UNITED STATES PATENT AND TRADEMARK OFFICE

10/584,276

Robert Cudini

DETAILED ACTION

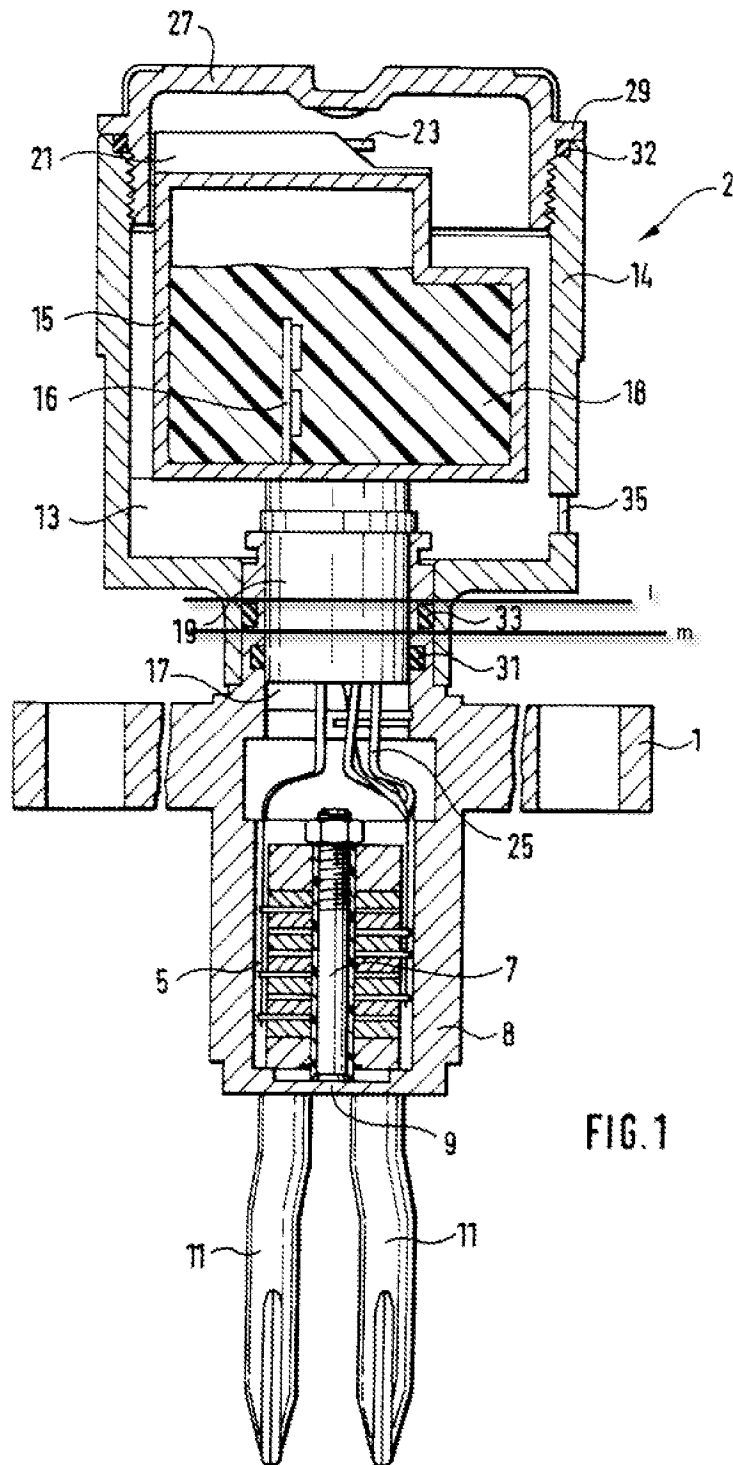
With respect to claim 28, Dreyer discloses the measuring device as claimed in claim 25 wherein: said seal [33] has on its outside, contacting the side wall of said connecting compartment, two sealing lips extending essentially in parallel with one another (see annotated Dreyer's figure 1 below).

With respect to claim 29, Dreyer discloses the measuring device as claimed in claim 27 wherein: said seal [33] is so arranged in said connecting compartment that the two sealing lips extend essentially in parallel with said gap in the side wall of said connecting compartment (see annotated Dreyer's figure 1 below and column 3, lines 52-61).

With respect to claim 30, Dreyer discloses the measuring device as claimed in claim 29 wherein: said seal [33] is so arranged in said connecting compartment that said gap in the side wall of said connecting compartment extends essentially between the sealing lips of the seal (see annotated Dreyer's figure 1 below and column 3, lines 52-61).

Note: sealing lips touching lines l and m are parallel.

FIG. 1

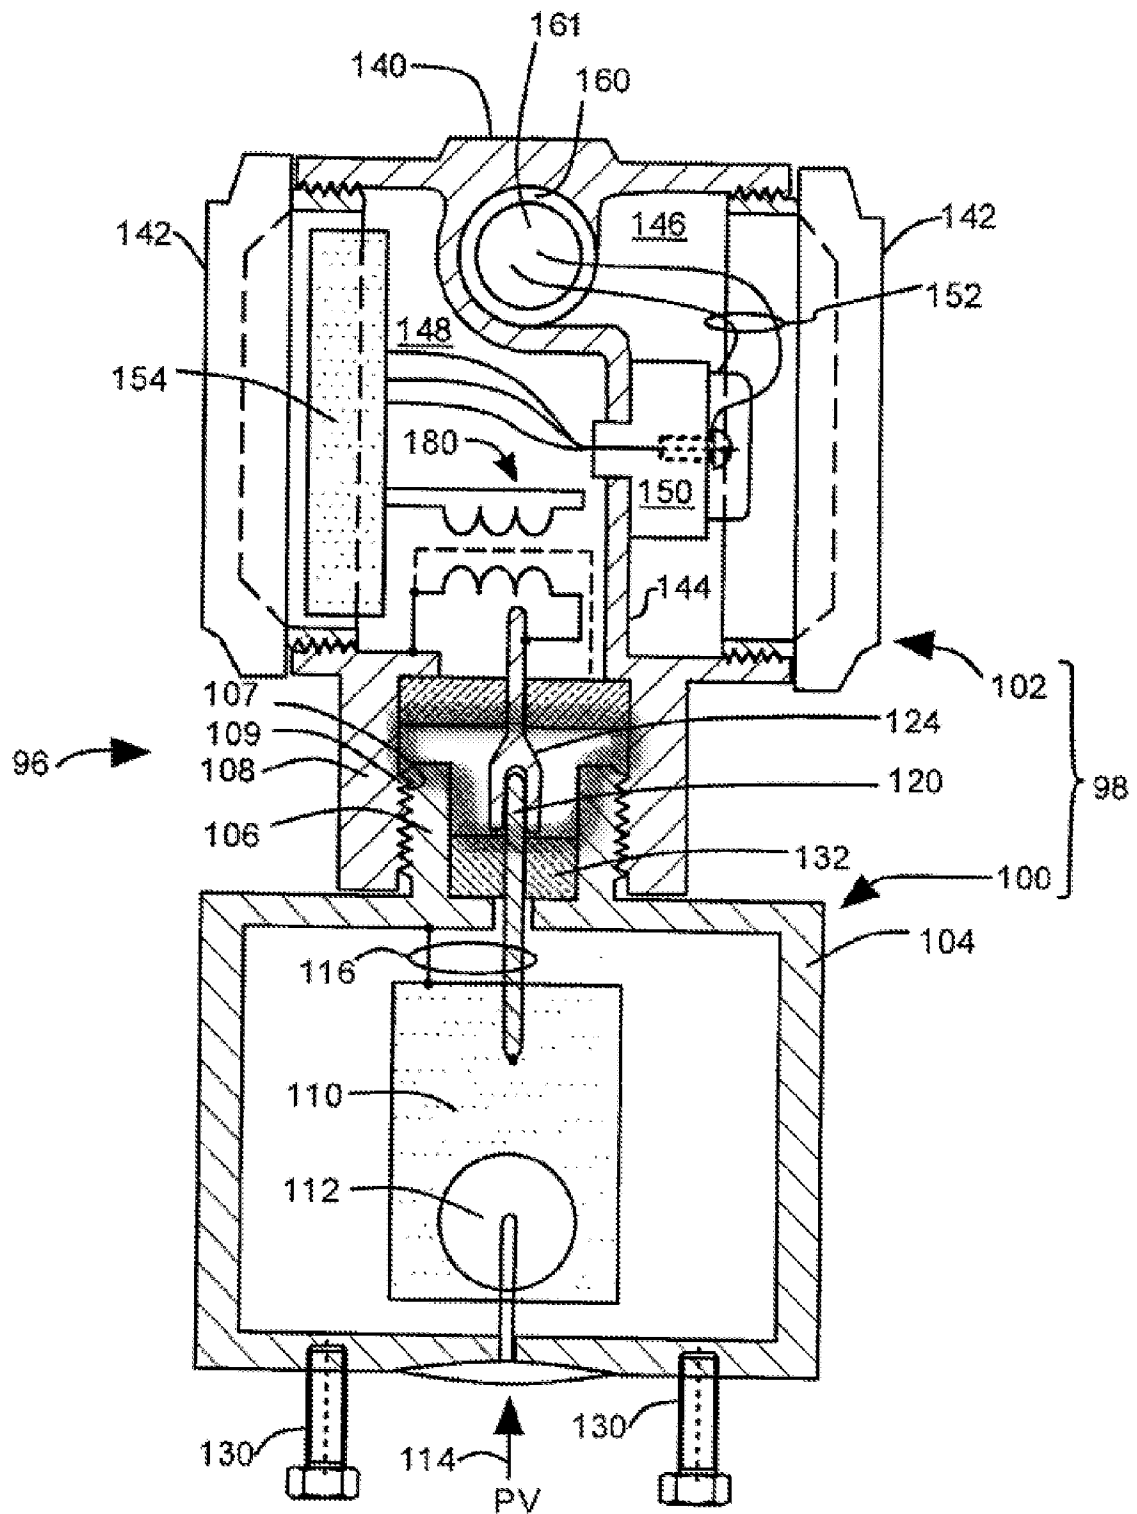
With respect to claim 21, the combination of Dreyer and Frick disclose all the claimed limitations of claim 20 above and also disclose that both said plug elements and said socket elements protrude into said connecting compartment (see annotated figure 1 of Frick below).

Note the highlighted connecting compartment region in which both 120 and 124 protrude into.
